College of Marin Facilities Master Plan and Learning Resources Center

Final Environmental Impact Report

SCH #2019110285

June 2020

Notes on Bolinas Marine Lab Geology

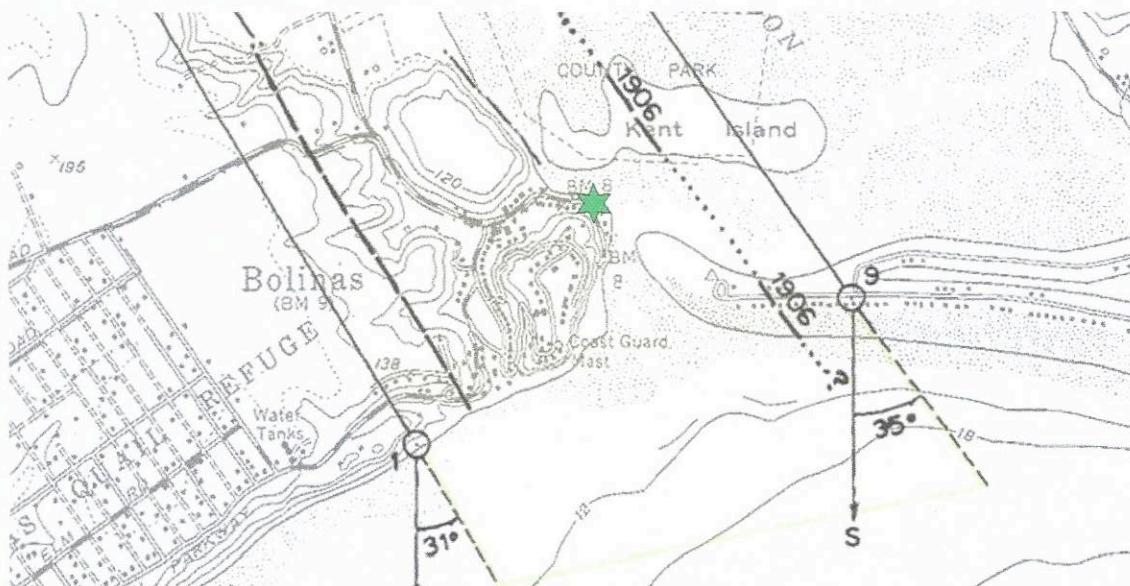
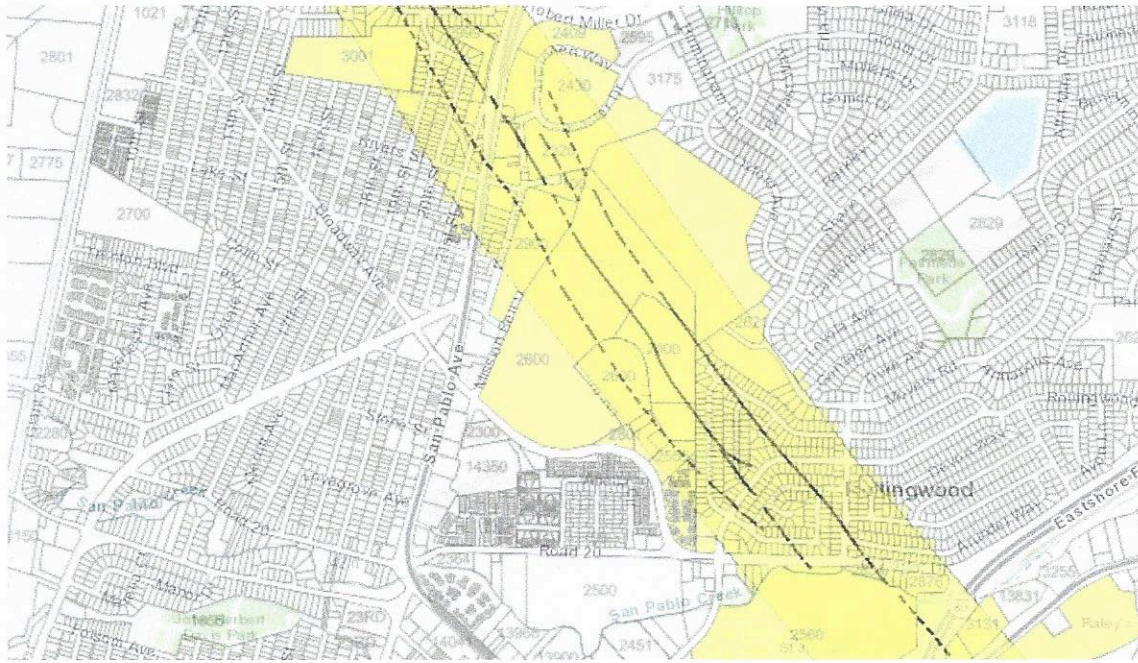
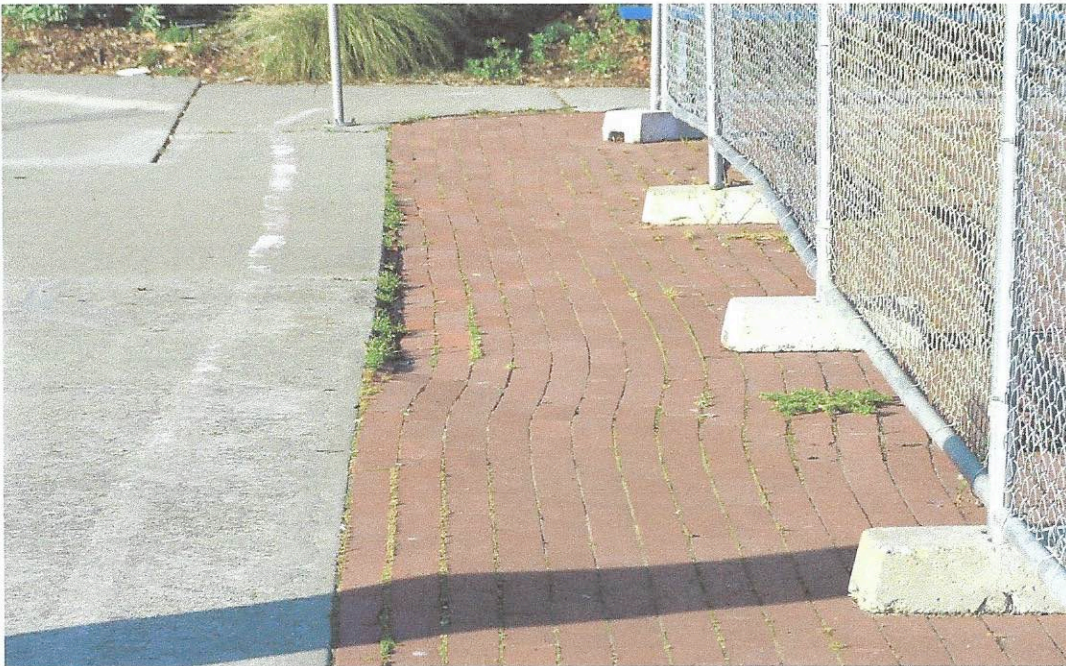
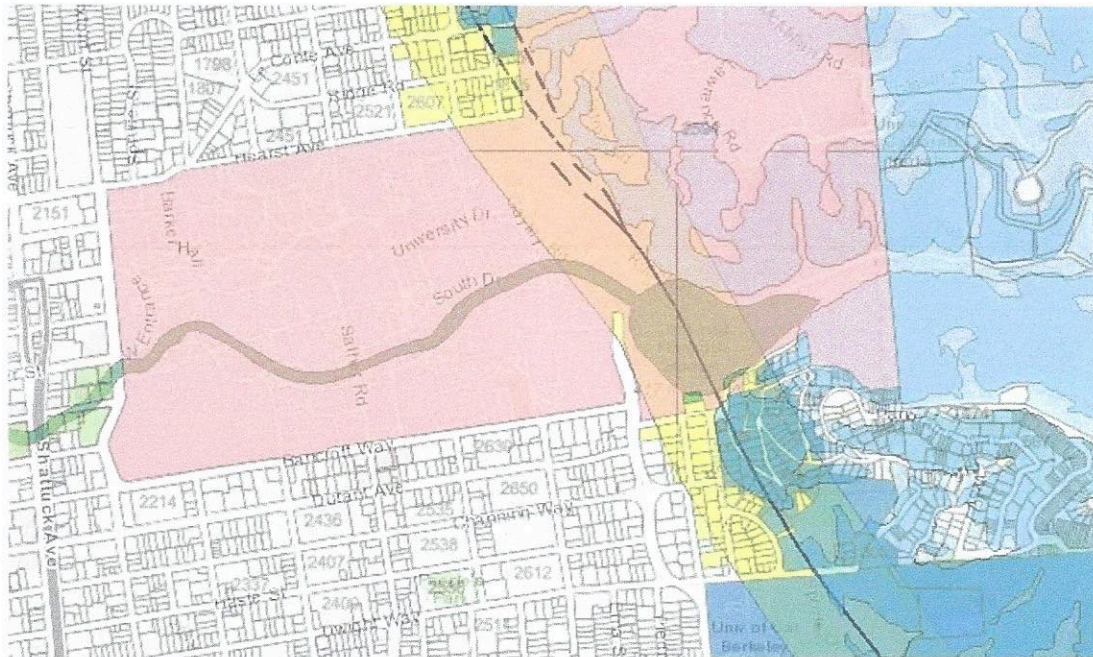
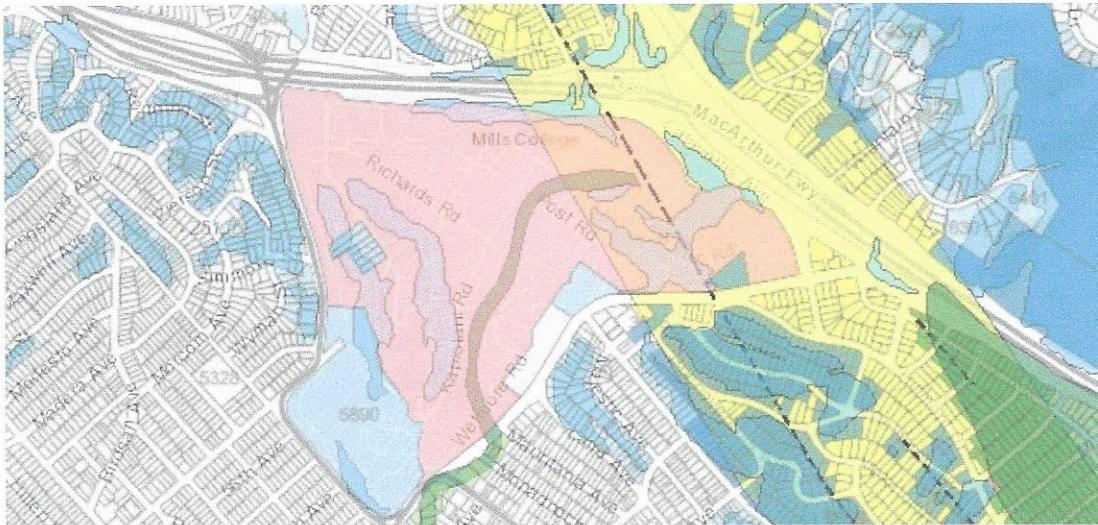
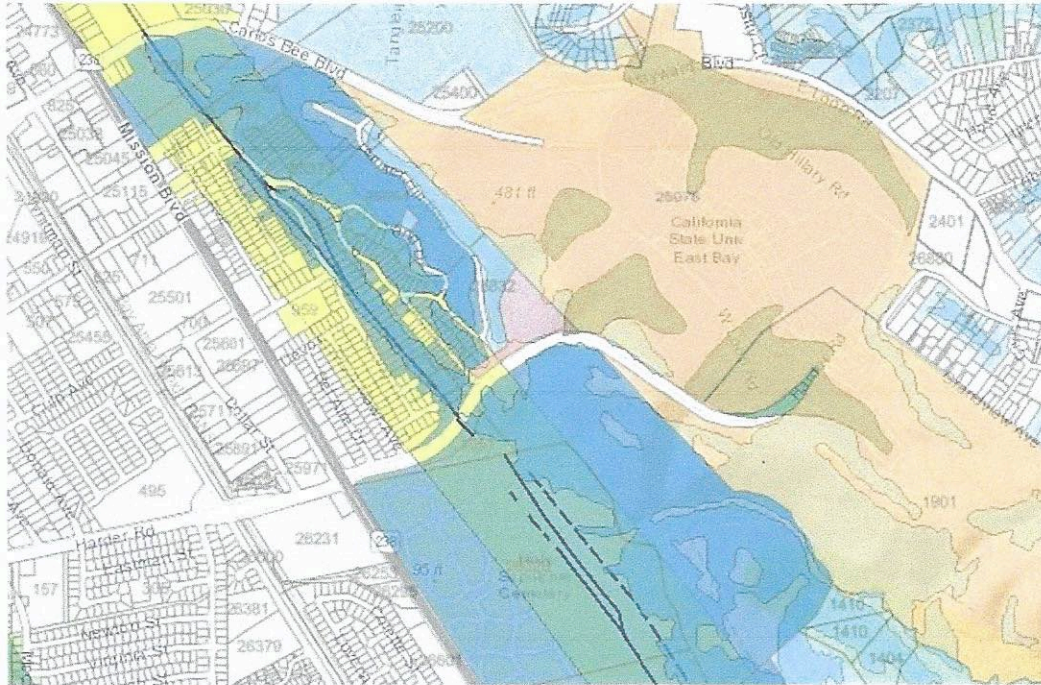
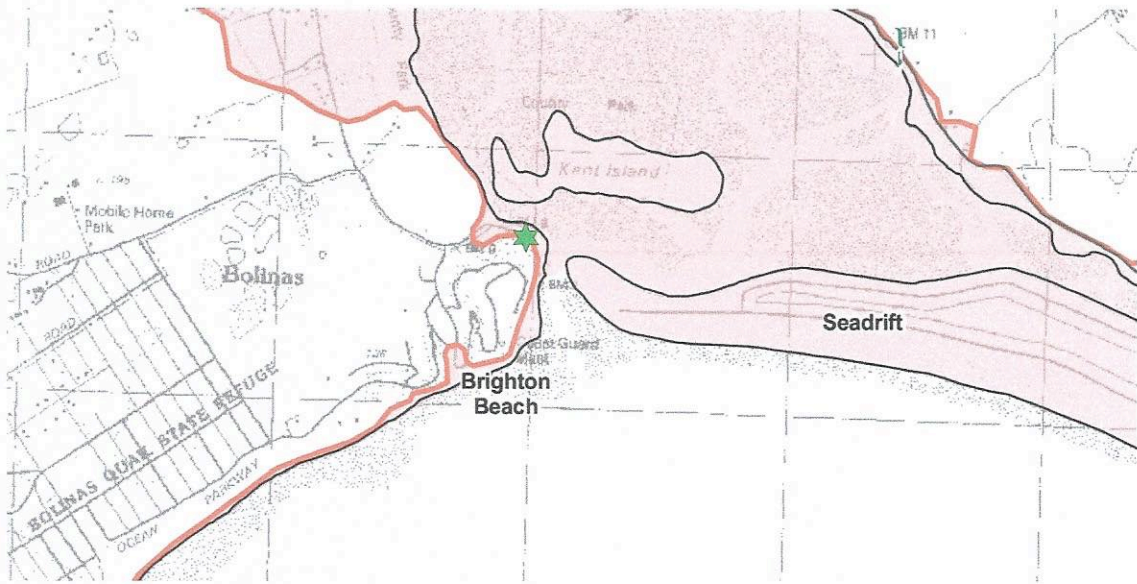
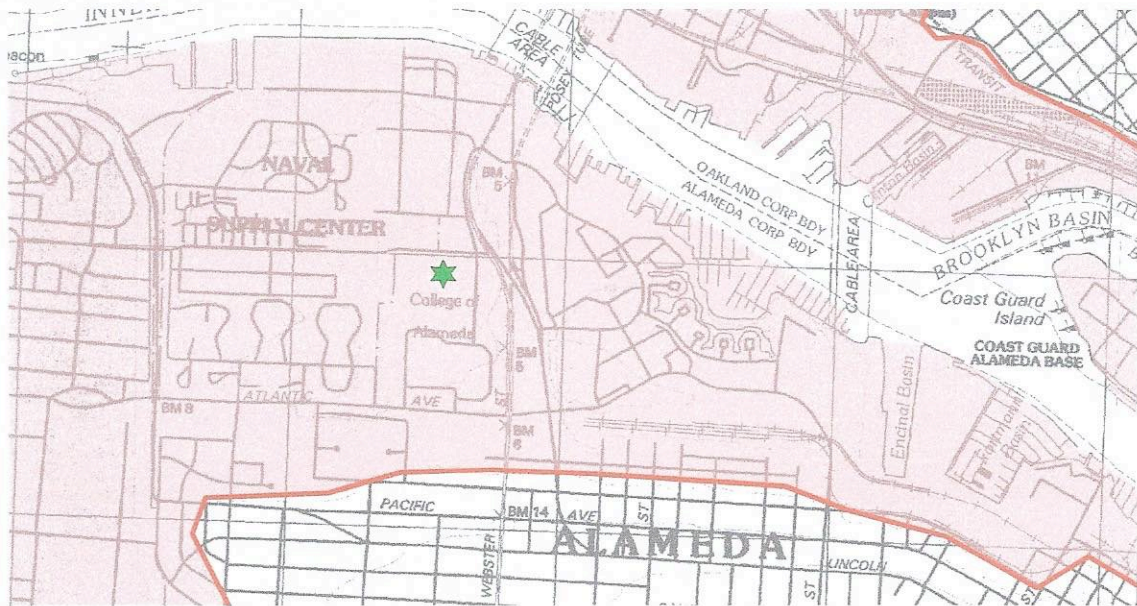
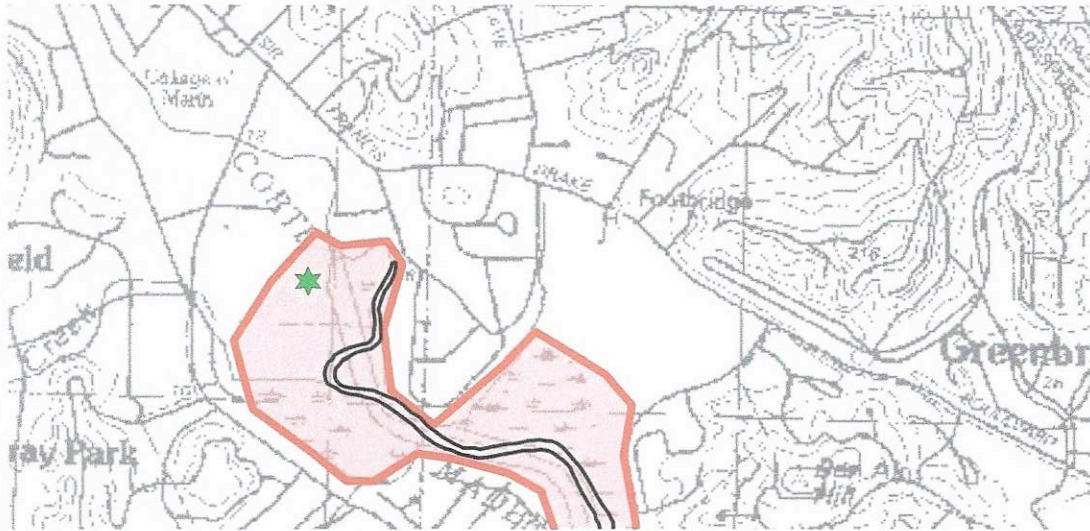
Recent discussions about the Bolinas Marine Lab have raised questions about the geologic suitability of the site in terms of earthquake fault proximity and tsunami danger.

While this note is not meant as a substitute for a formal site study by a geologist licensed by the state of California, there are publicly available resources that can help start discussions about the possible issues at hand, and give perspective on the risks faced by schools in similar situations.

This diagram suggests that the Bolinas Marine Lab may be significantly more than 50 feet from either of the major mapped faults.

However, this site is not unique in its proximity to the tsunami inundation zone, nor is it the only community college affected by this issue.

Presumably, this tsunami hazard did not preclude College of Alameda from being built, nor did it impose a restriction upon renovations.
